## HISTORIC AND DESIGN REVIEW COMMISSION

September 19, 2018

**HDRC CASE NO:** 2018-432  
**ADDRESS:** 827 LAMAR ST  
**LEGAL DESCRIPTION:** NCB 1368 BLK 5 LOT 20  
**ZONING:** R-6, H  
**CITY COUNCIL DIST.:** 2  
**DISTRICT:** Dignowity Hill Historic District  
**APPLICANT:** Oscar Santana/JAS Builder  
**OWNER:** McCleskey Holdings LLC  
**TYPE OF WORK:** Construction of a side and rear addition, window replacement  
**APPLICATION RECEIVED:** August 27, 2018  
**60-DAY REVIEW:** October 26, 2018  
**REQUEST:**

The applicant is requesting a Certificate of Appropriateness for approval to:

A-3.0

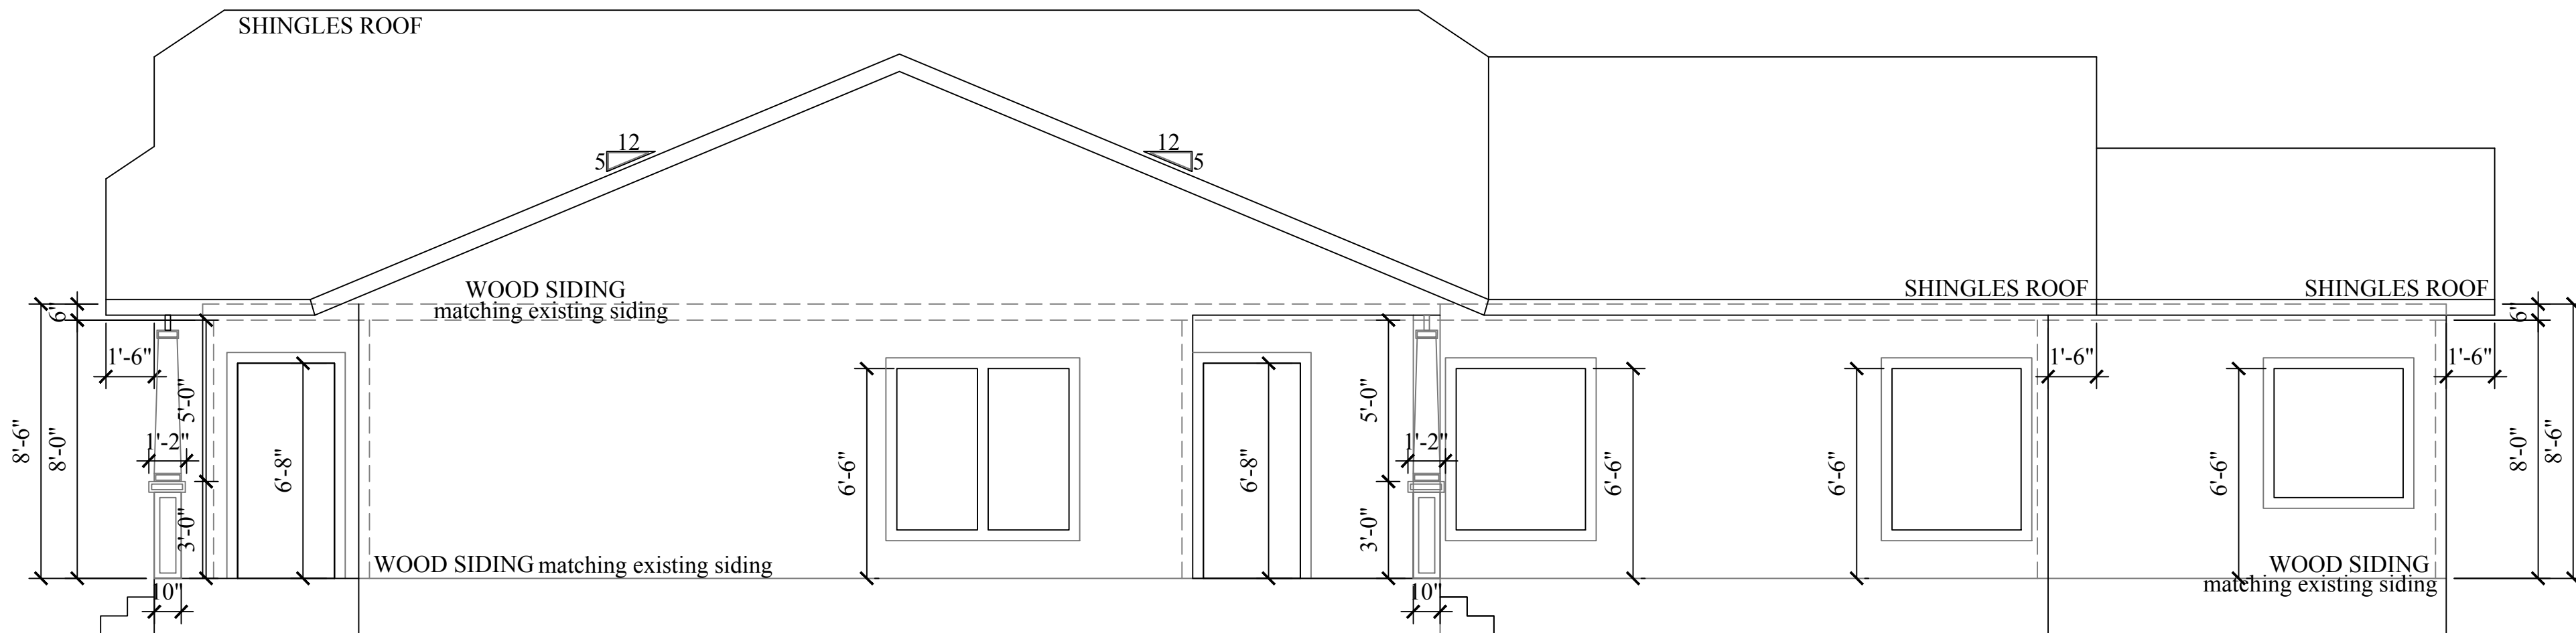
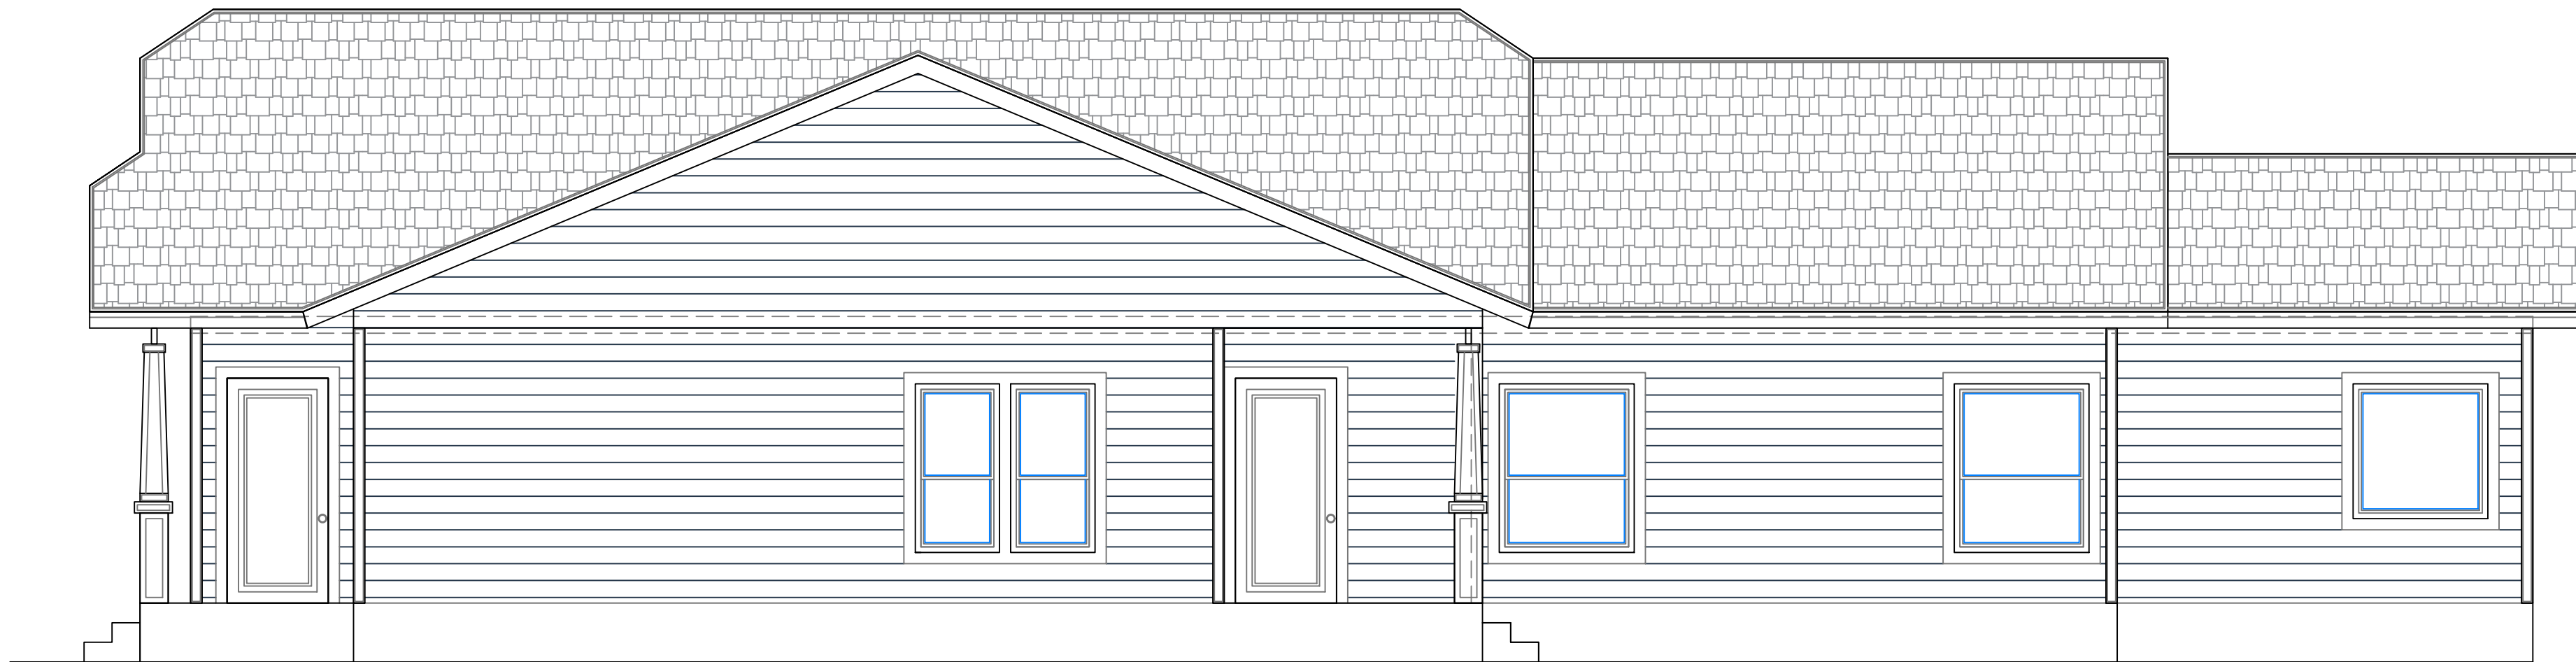
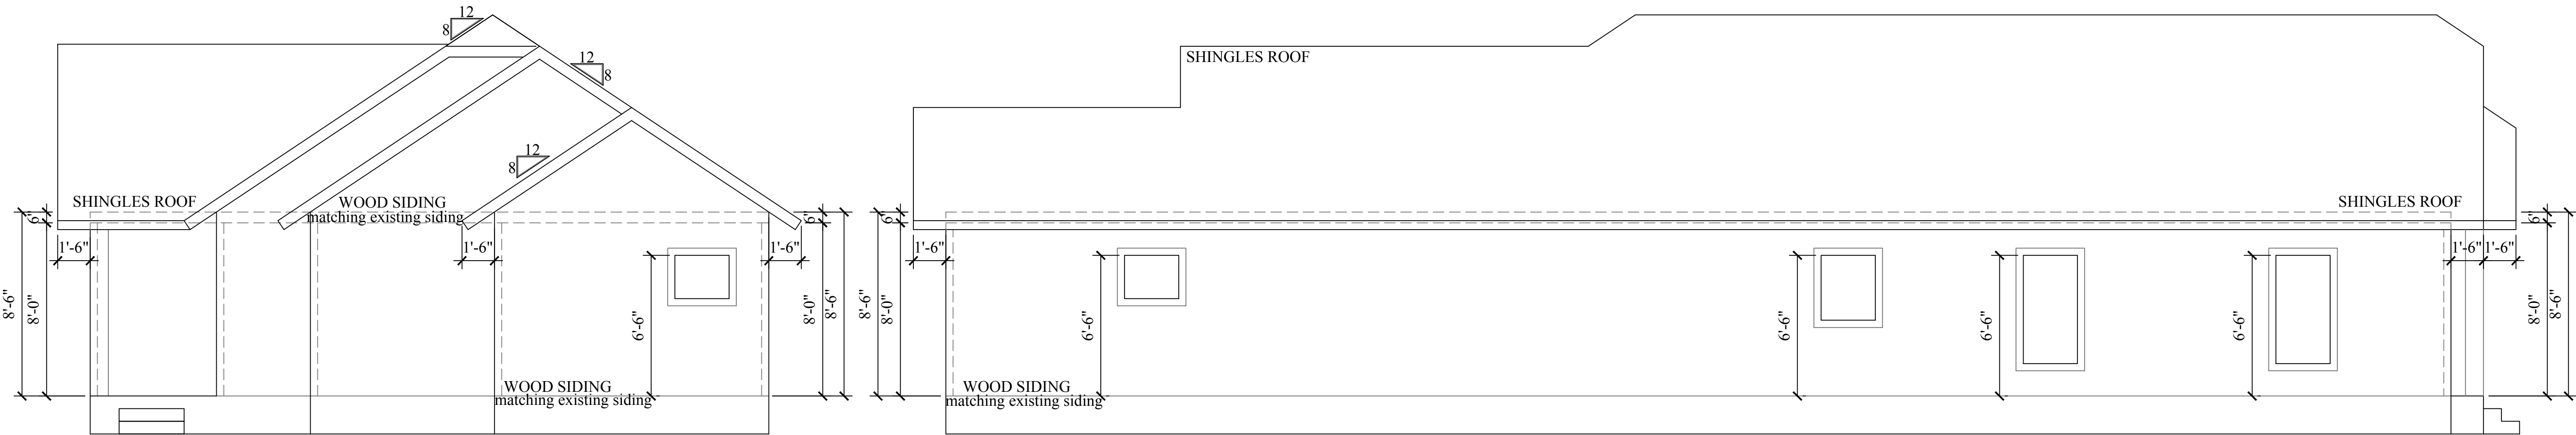
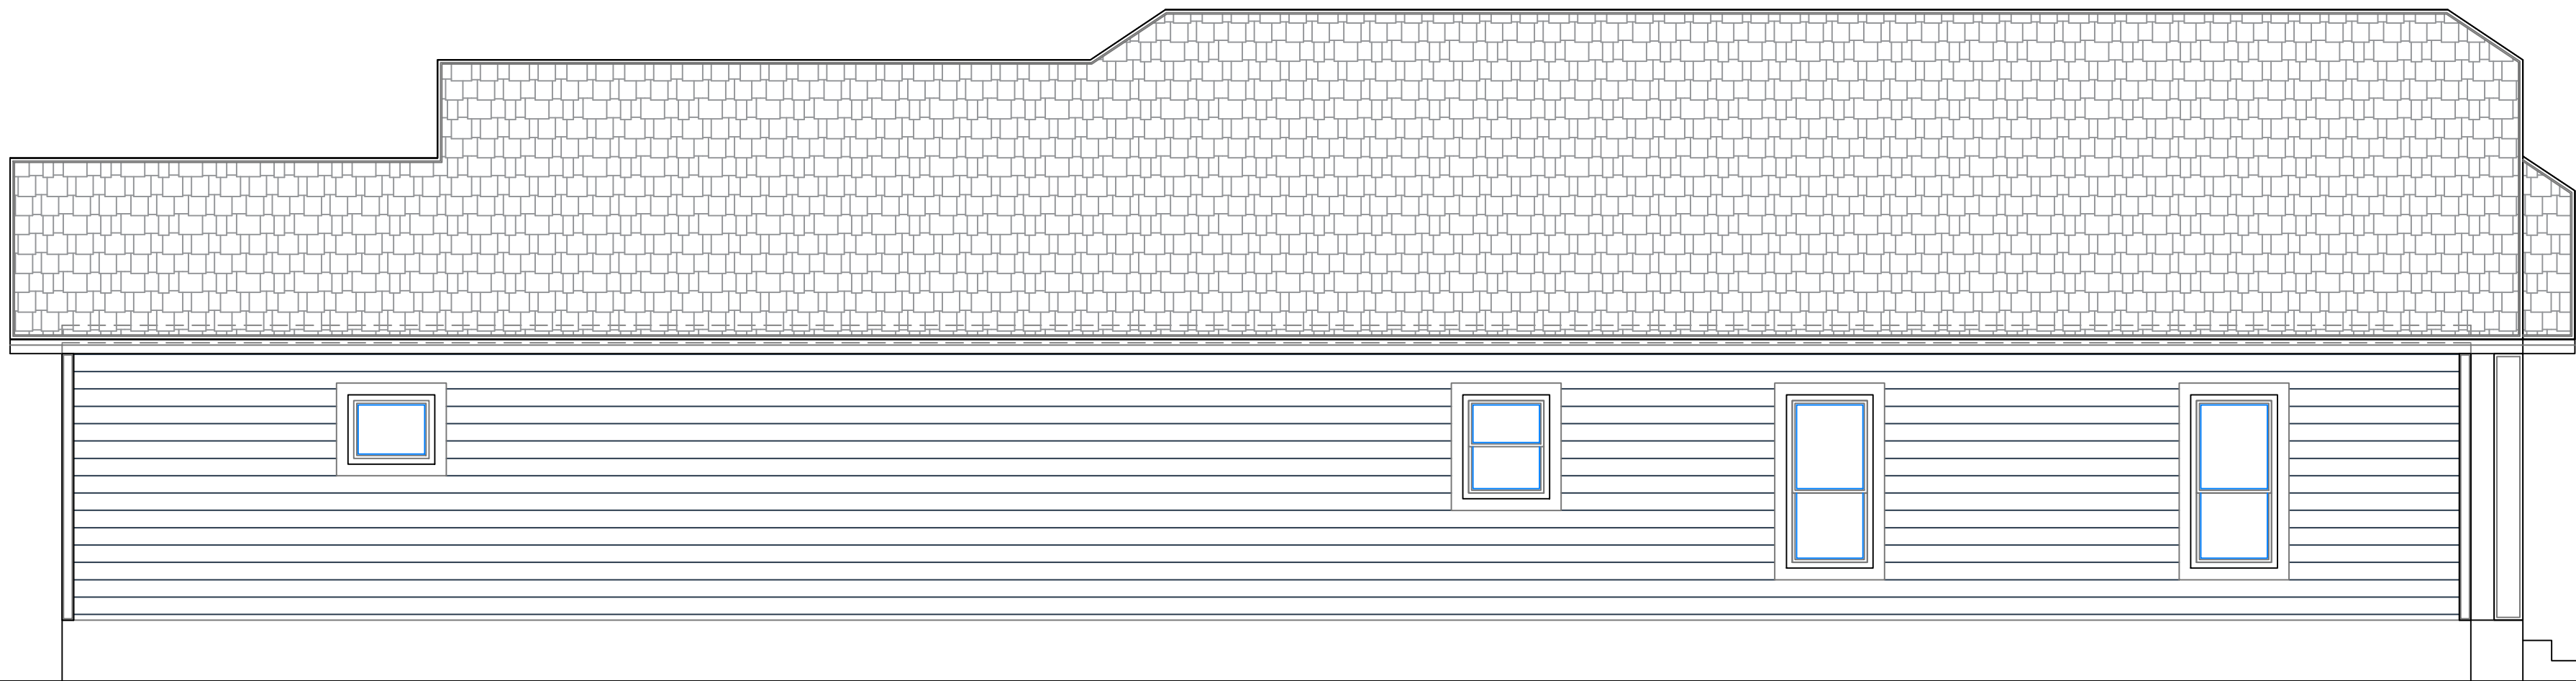
- j. **FENESTRATION** – The applicant has proposed for the addition to feature long expanses of walls without windows as well as windows that feature profiles that are inconsistent with the Guidelines, which note that the shapes of window openings should relate to those found on the historic structure. Staff finds that the incorporation of large, fixed windows is inappropriate. Additionally, staff recommends the applicant add window openings to the north and west facades.

- k. **ARCHITECTURAL DETAILS** – As noted in finding j, additional fenestration should be added to the north and west facades. Generally, staff finds the proposed massing and form to be appropriate.

- ii. That the applicant modify the proposed fenestration patterns to include window openings that match those found on the historic structure and incorporate additional window openings as noted in findings j and k.
